THIS DRAWING INDICATES THE LAYOUT OF MECHANICAL SERVICES ONLY.

Job
2-24, GLOUCESTER AVE. 640
Drawing LOWER GROUND FLOOR PLAN (MECHANICAL SERVICES) M-18A
Scale: 1:50 Date: AUG. 73

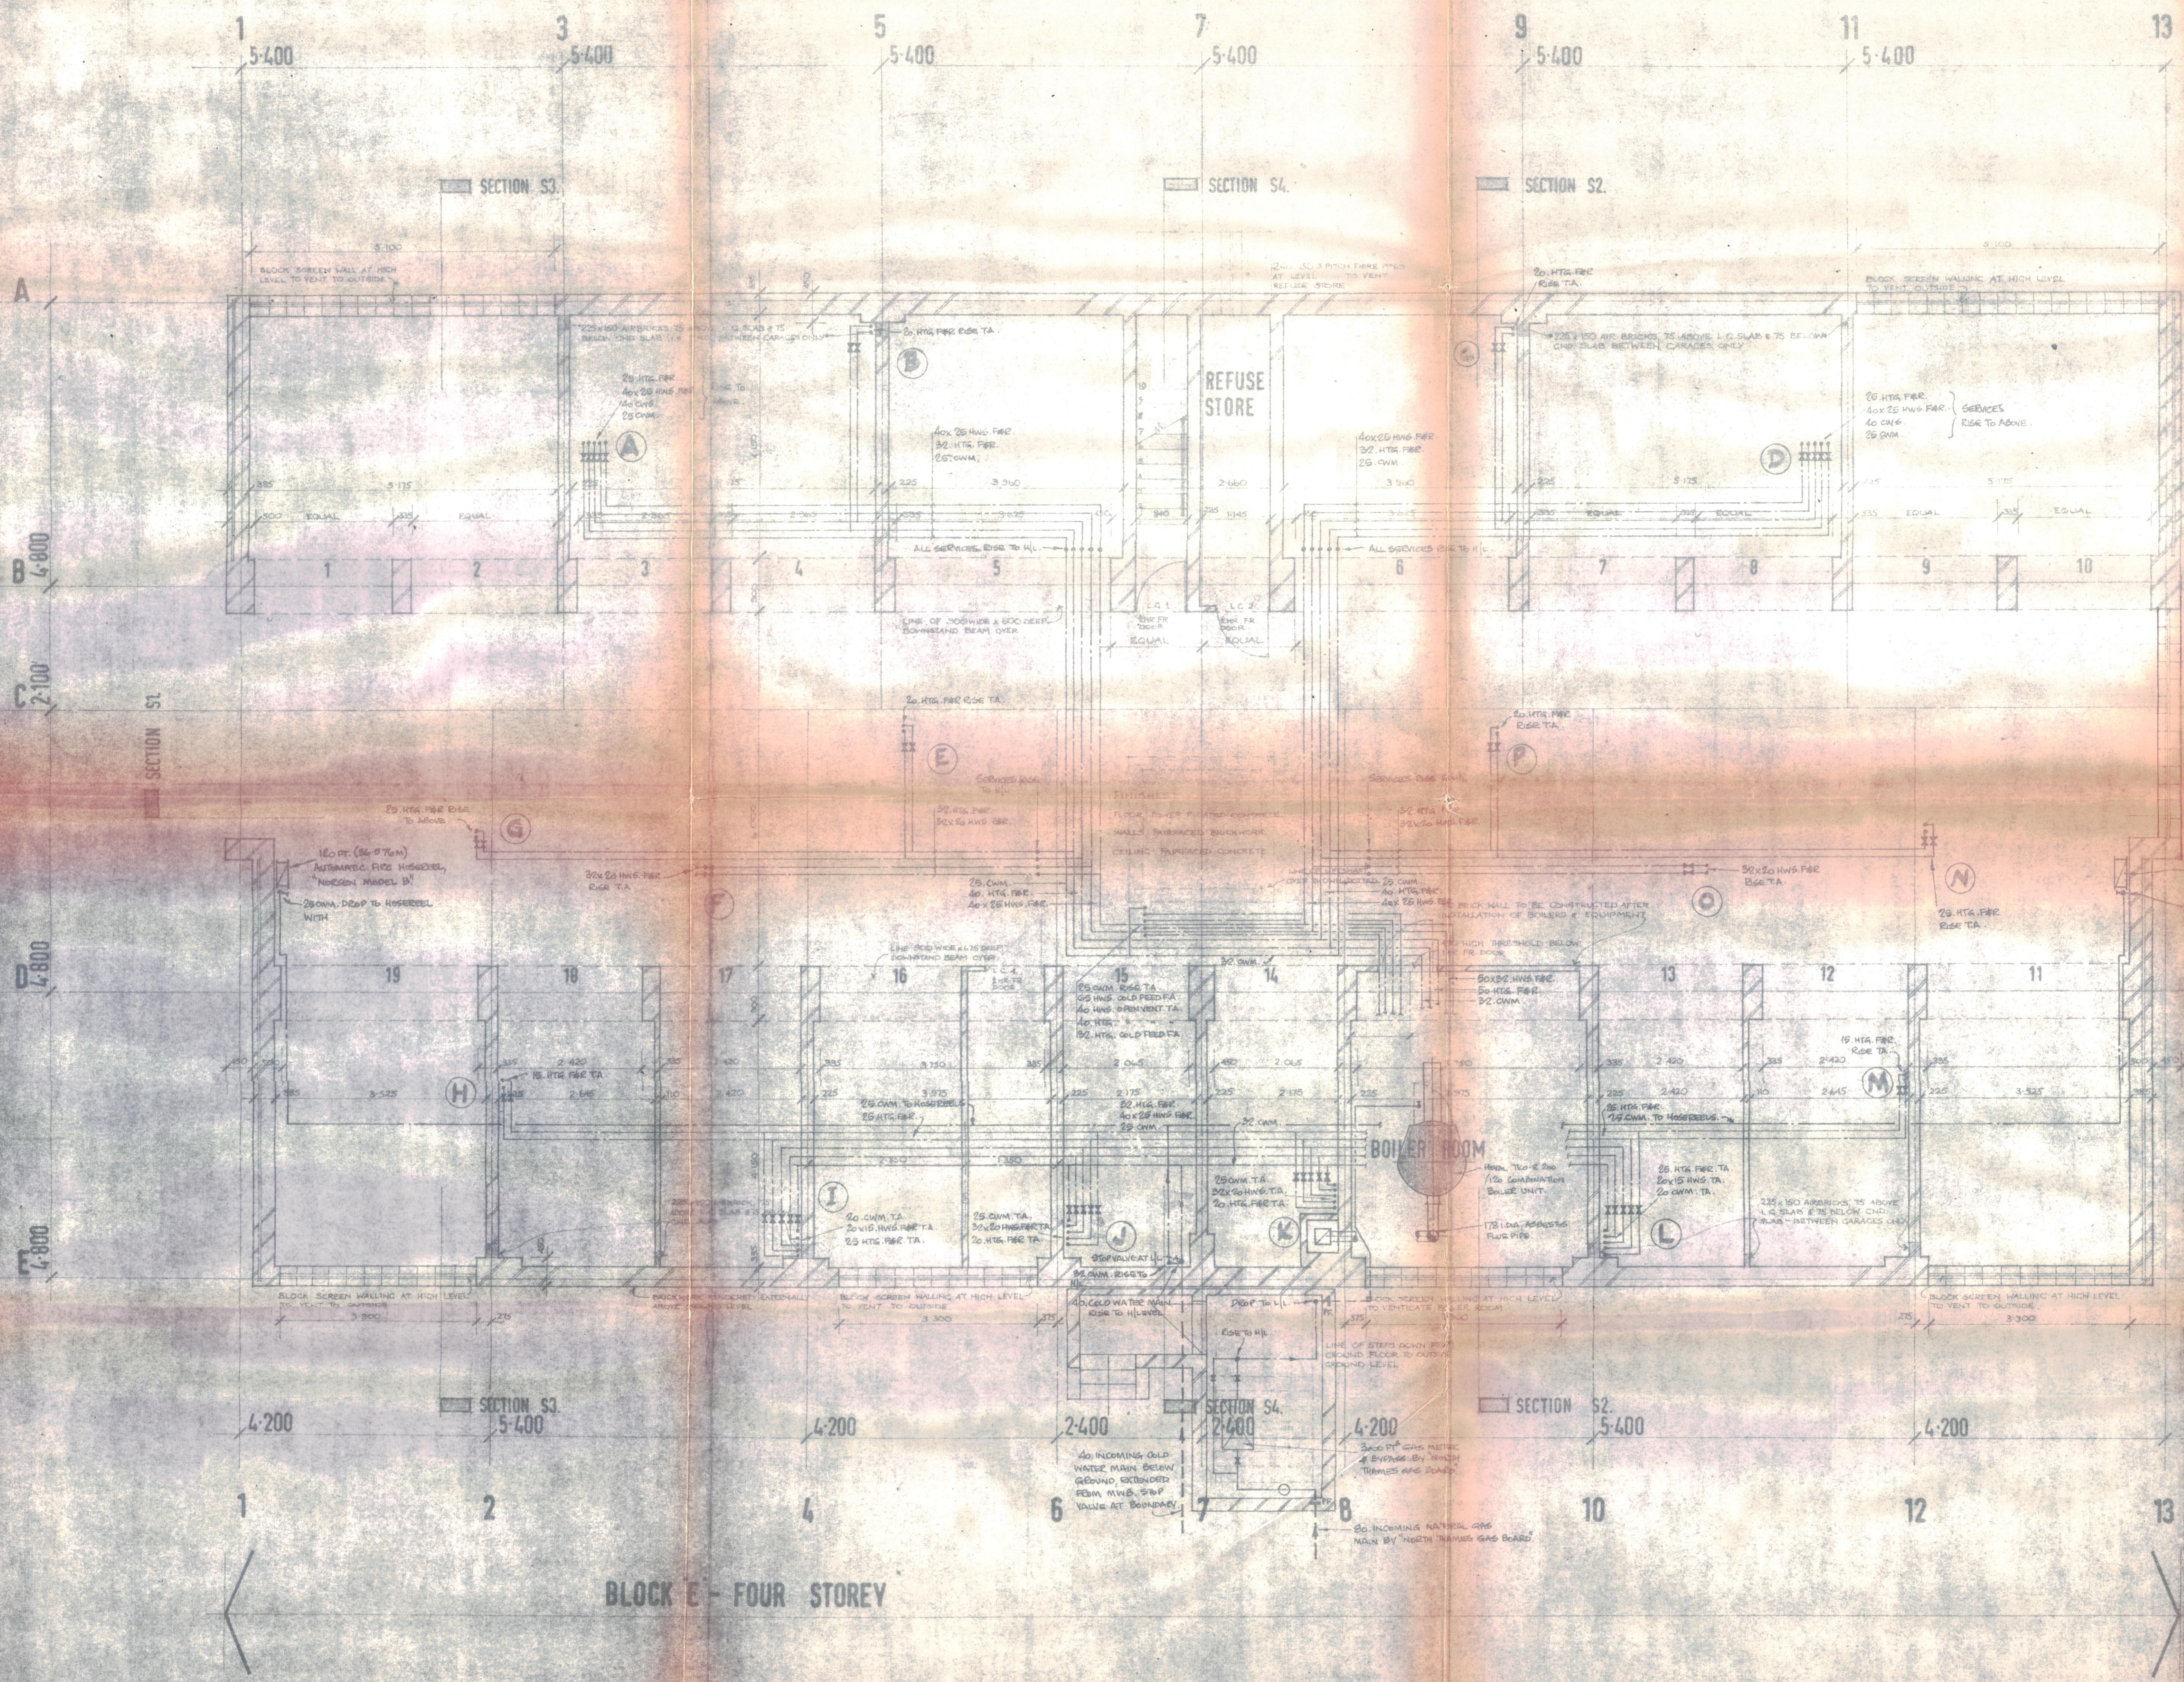
A
OMIT THROUGH WAY.
FILL IN OPENING WITH BRICKWORK AND BLOCK SCREEN WALLING AT HIGH LEVEL TO VENT OUTSIDE. ALL DETAILS TO MATCH FIRST OF BUILDING.
SEE ALSO DWG. NO. 61.055 EAST ELEVATION
DWG. NO. 2.14A LOWER GROUND FLOOR PLAN.

B
1/2" (34.97mm) AUTOMATIC FIRE RUSHREEL, NORGEN MODEL B.
DISCH. W/9.9 TO ROSEBELL
W/10 ISOLATING VALVE TO BS.1010.

OMIT THROUGH WAY
FILL IN OPENING WITH
BRICKWORK AND BLOCK
SCREEN WALLING AT HIGH LEVEL TO VENT
OUTSIDE
